Town of Milford Meeting Notice

Board or Commission: Conservation Commission

Date and Time of Meeting: Wednesday April 21, 2021 at 7.00 P. M

BUILDING PERMIT
PLAN OF LAND
#77 CAMP STREET
IN
MILFORD, MA
SCALE: 30 FEET TO AN INCH
DATE: FEBRUARY 3, 2021

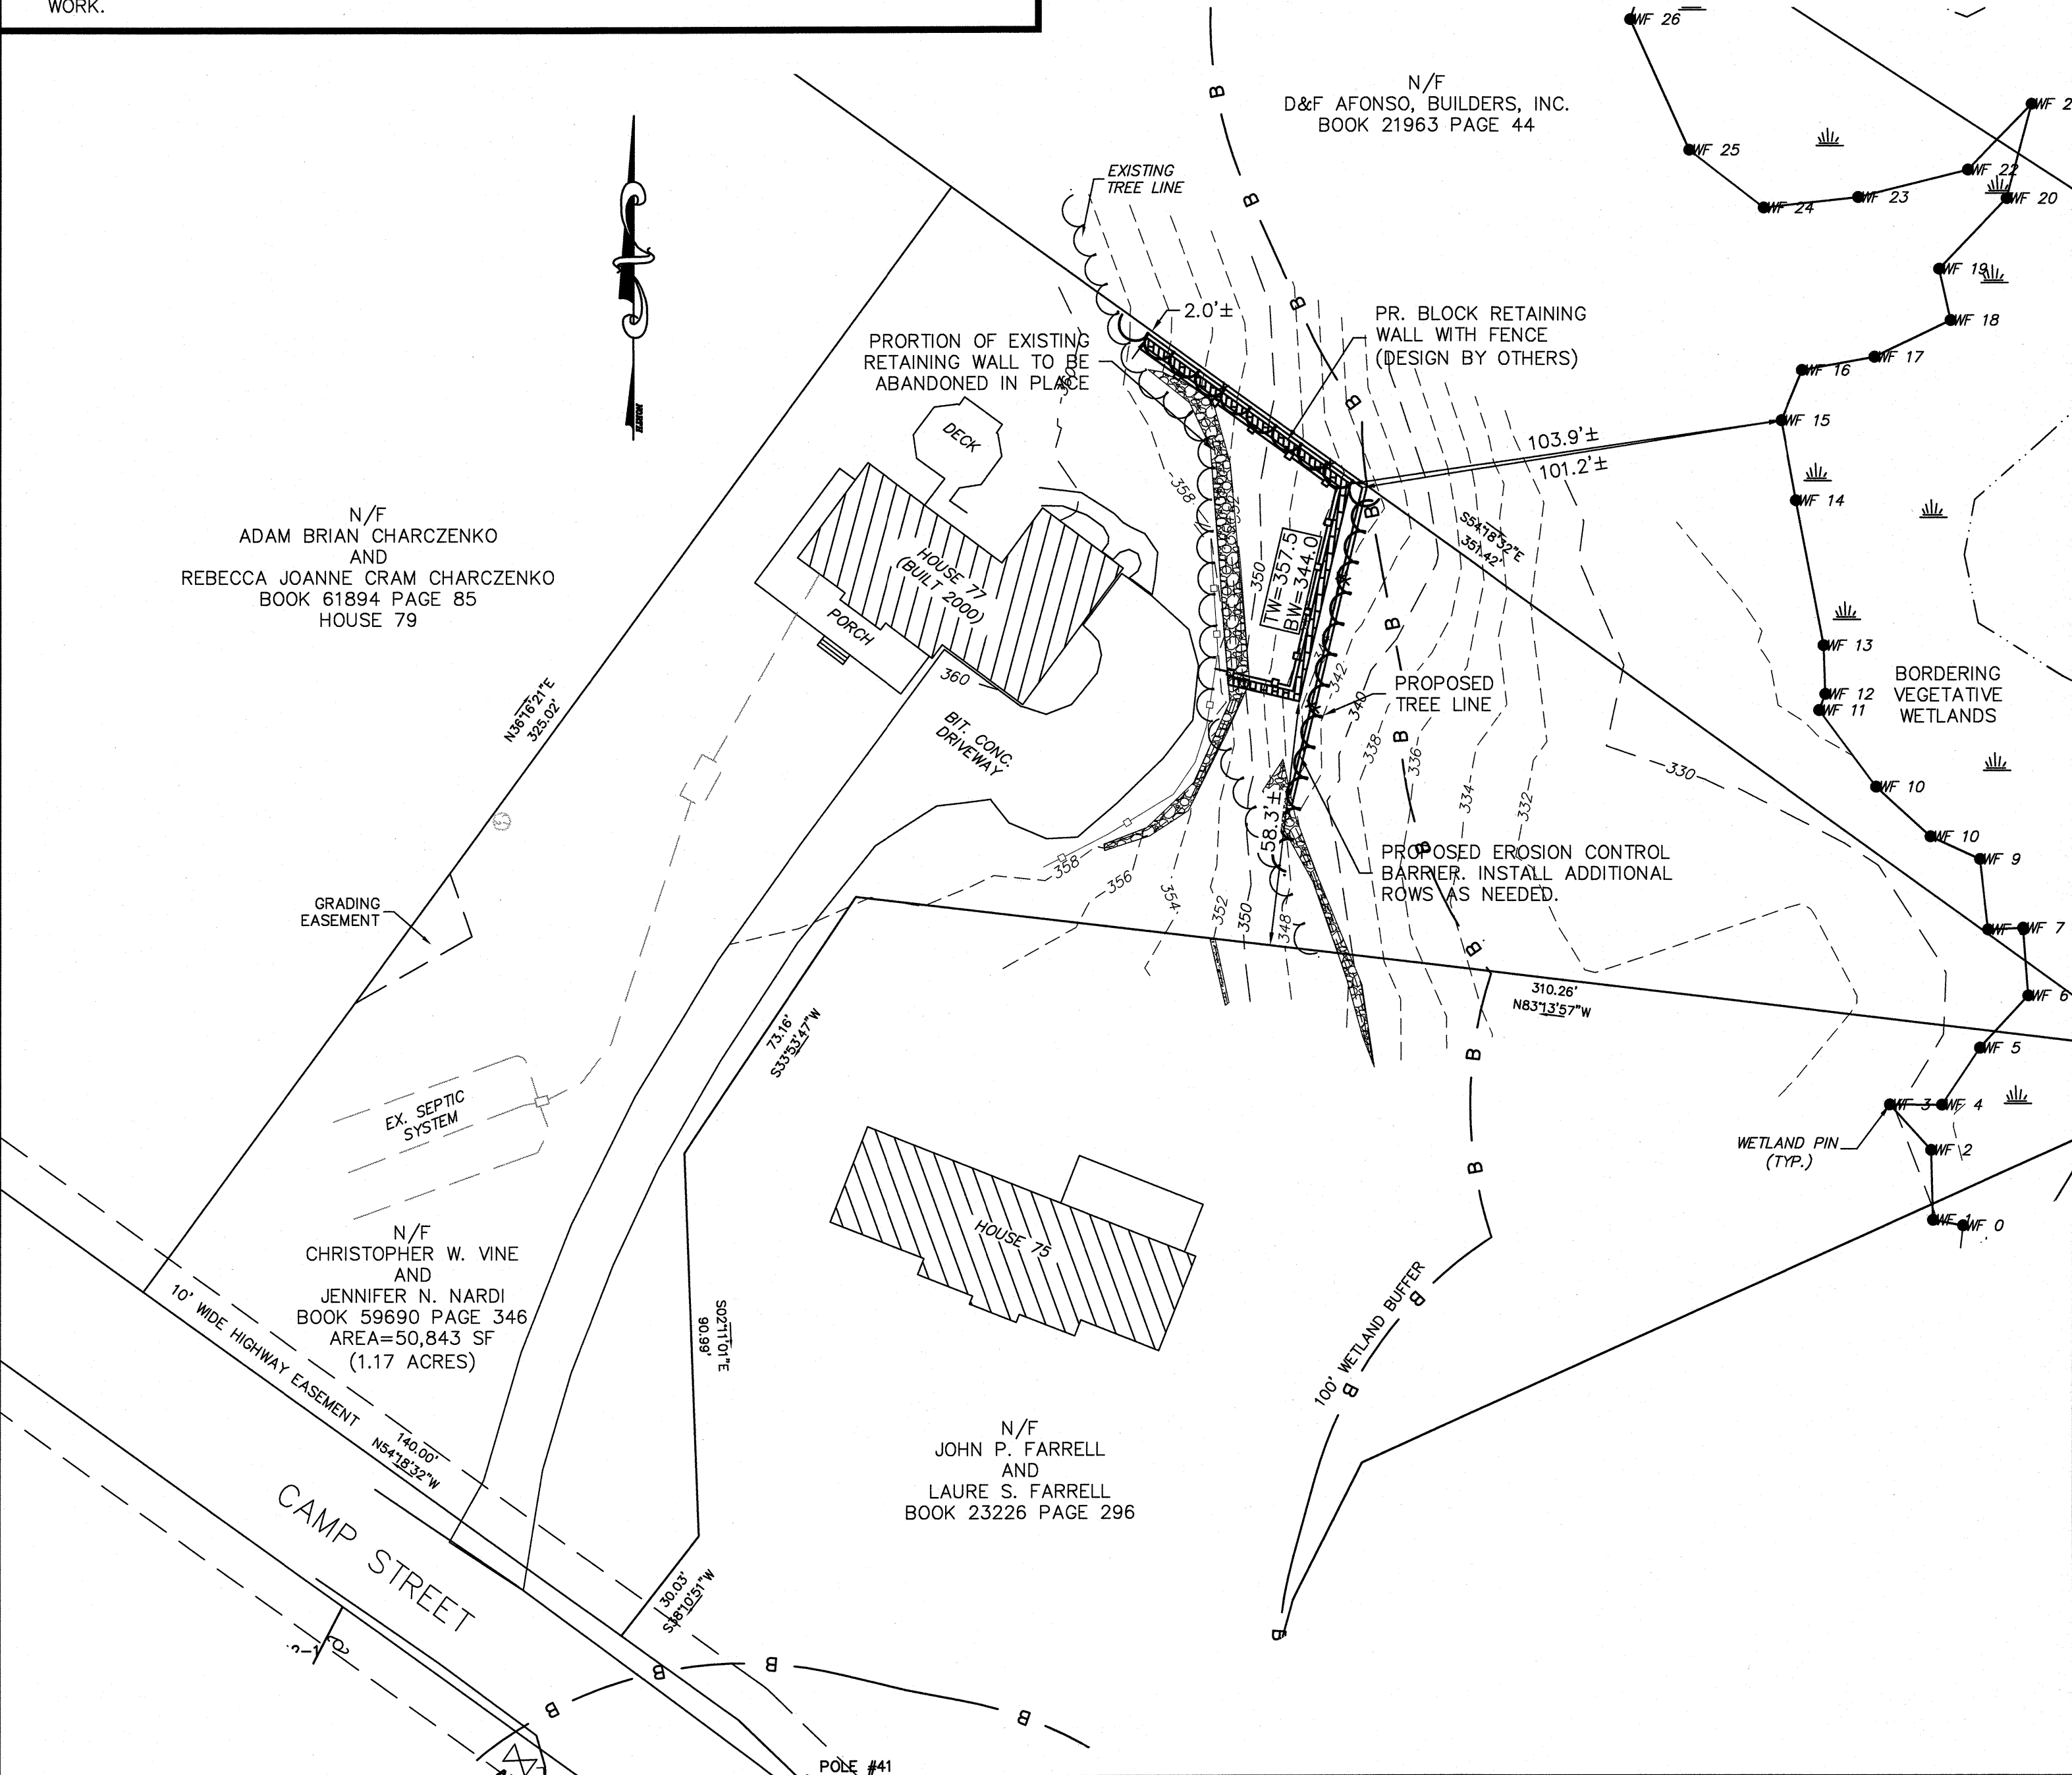
The Applicant has formally **withdrawn** the Notice of Intent (NOI) filing associated with the expansion of a yard area associated with an existing single-family house. The applicant is Christopher Vine, 77 Camp Street, Milford, MA 01757.

The applicant has changed the design plans to reflect a much smaller retaining wall with all of the work being outside of the 100-foot buffer zone to the BVW.

On behalf of the applicant, Christopher Vine, we are requesting to withdraw our Notice of Intent for the expansion of a lawn area and construction of a retaining wall including the associated grading and landscaping within the 100 ft. buffer of a bordering vegetated wetland. Enclosed, please find one (1) copy of the revised Building Permit Plan of Land showing the proposed work which has been relocated outside of the 100 ft. buffer.

I recommend the commission simply recognize the formal withdrawal of the application.

TITLE:
**GRADING,
 DRAINAGE &
 EROSION CONTROL
 PLAN**
 For
**M-3 Marijuana Grow
 Facility**
 On
5-7 Industrial Road
 In
 Milford, Massachusetts

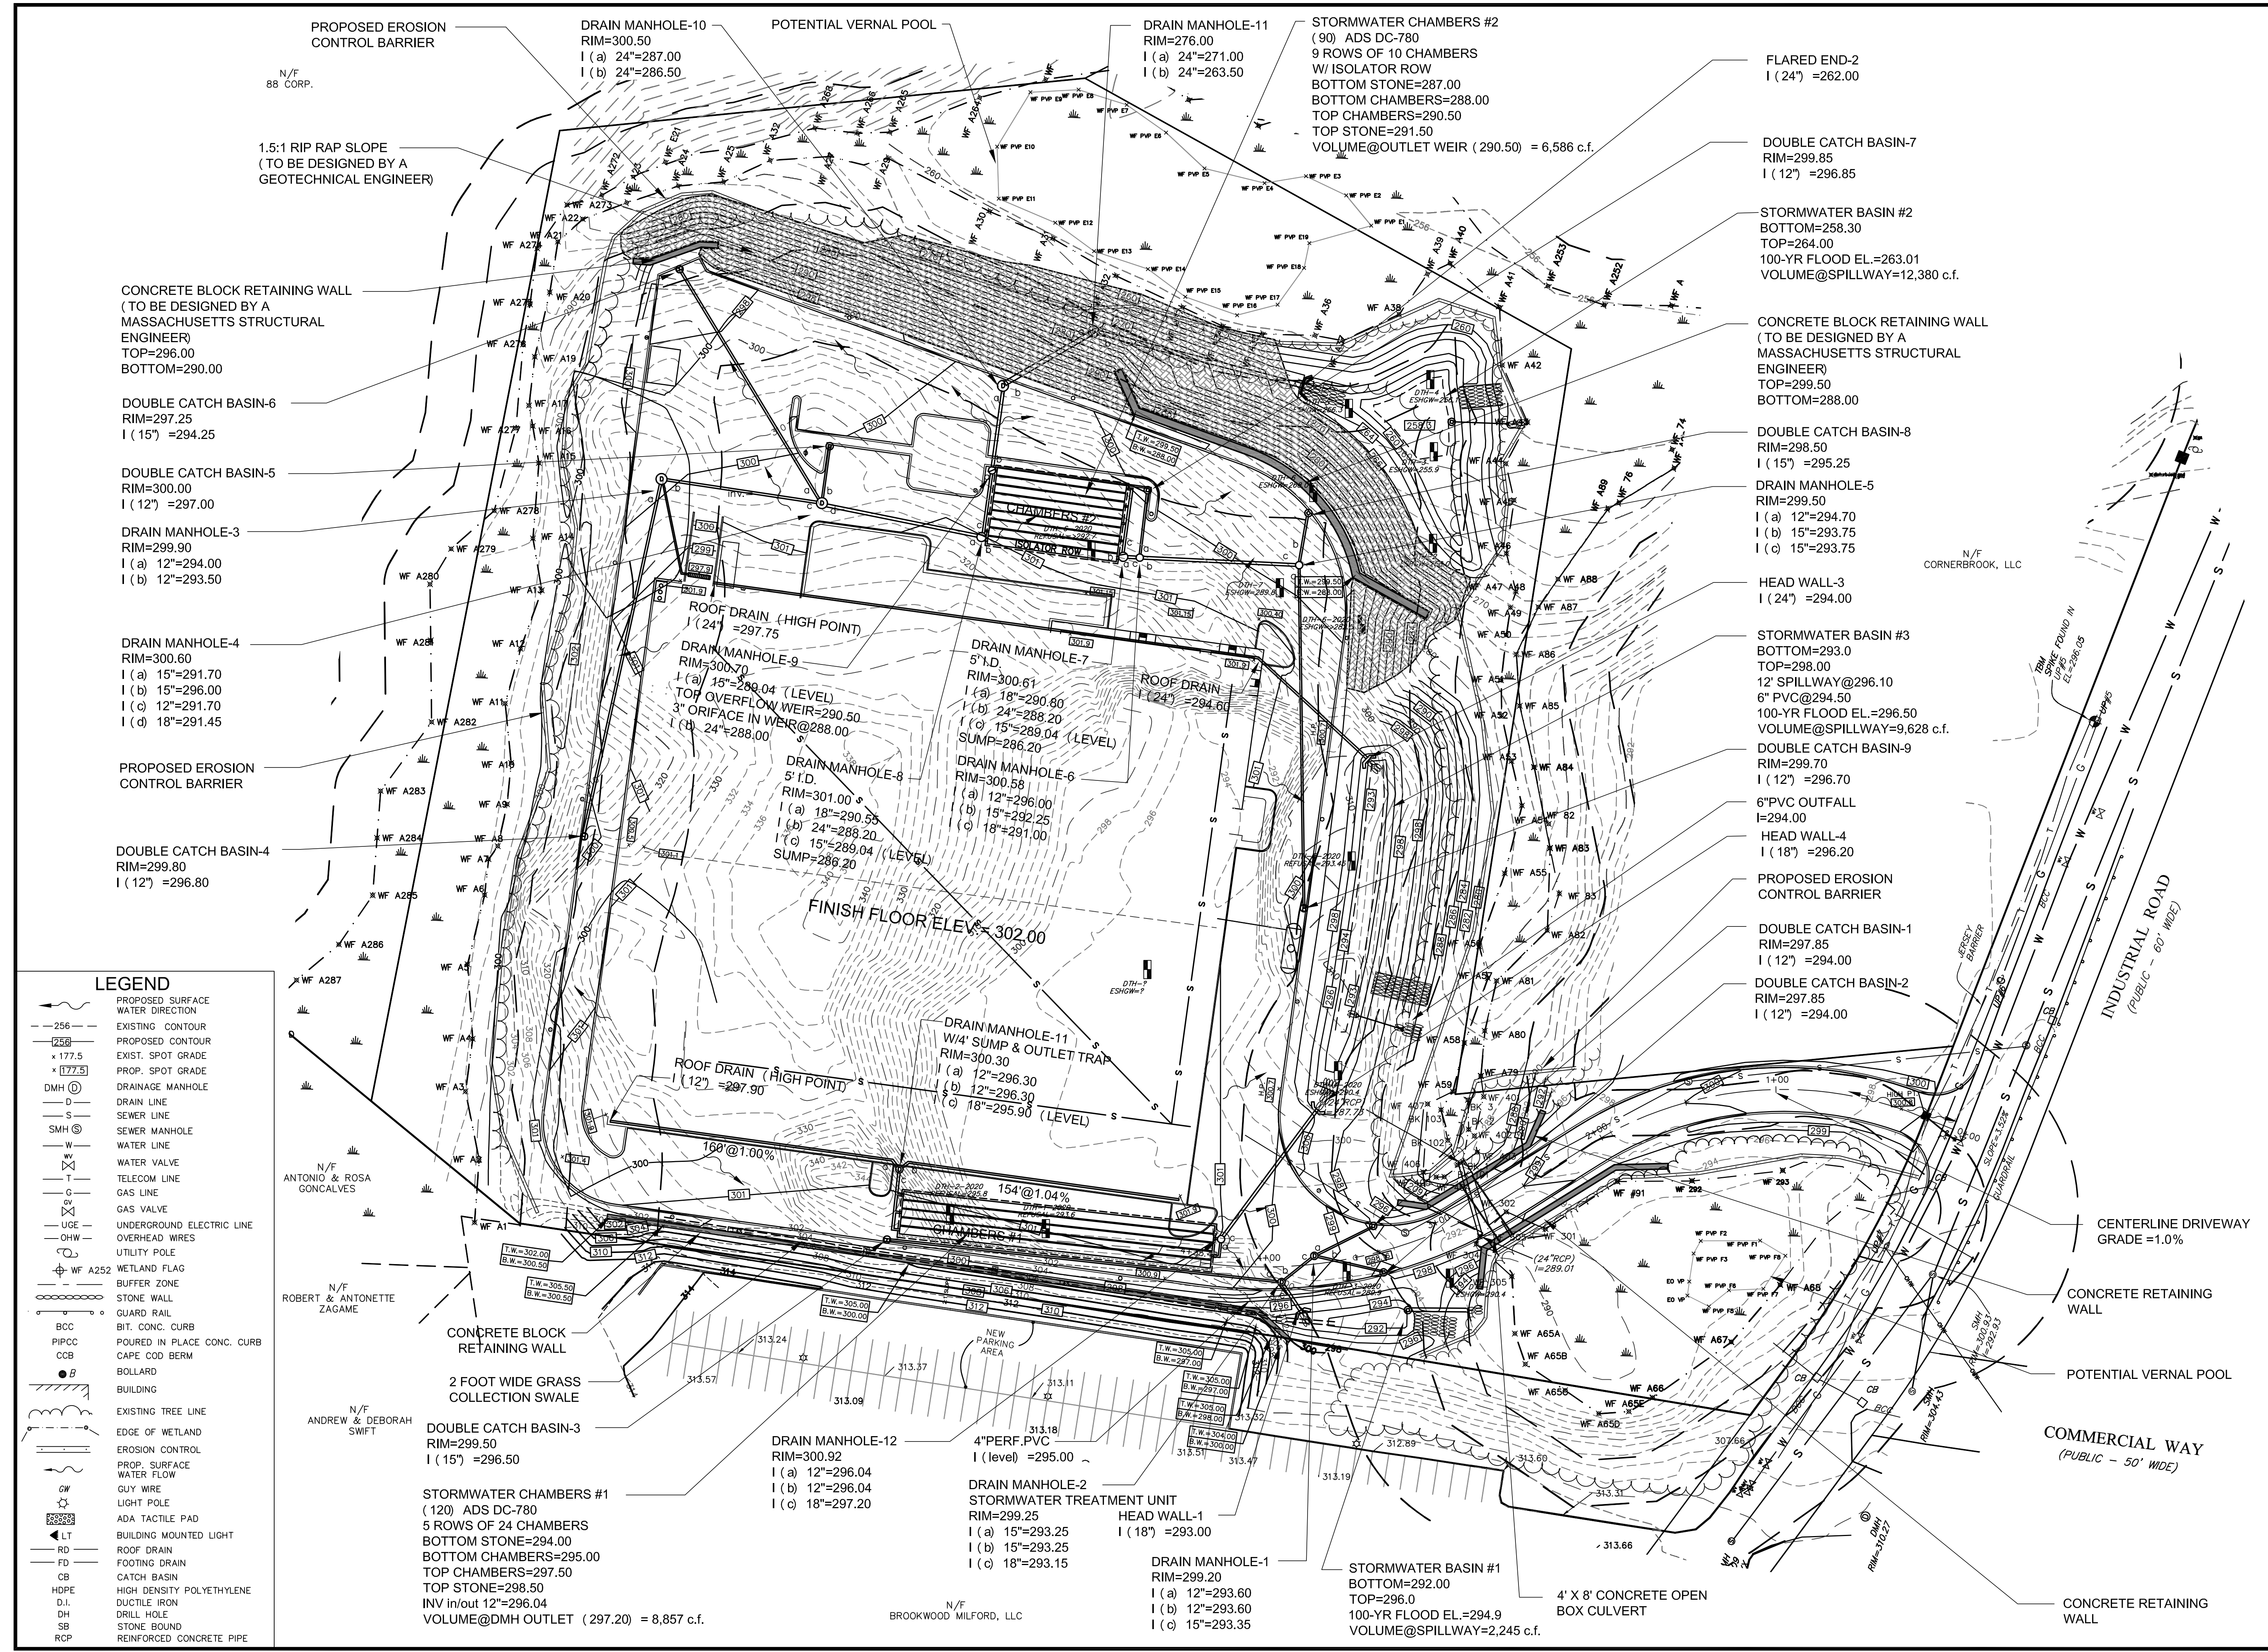
The Site was approved by the Commission in June, 2020. The amendment is associated with the addition of proposed retaining walls. The limit of work is the same as the approved plans.

Special Condition #27 states that an Amended Order of Conditions is necessary if any significant changes are made to the approved plan. The addition of a retaining wall in the northeast portion of the project has triggered this threshold. Enclosed for your review are the following documents:
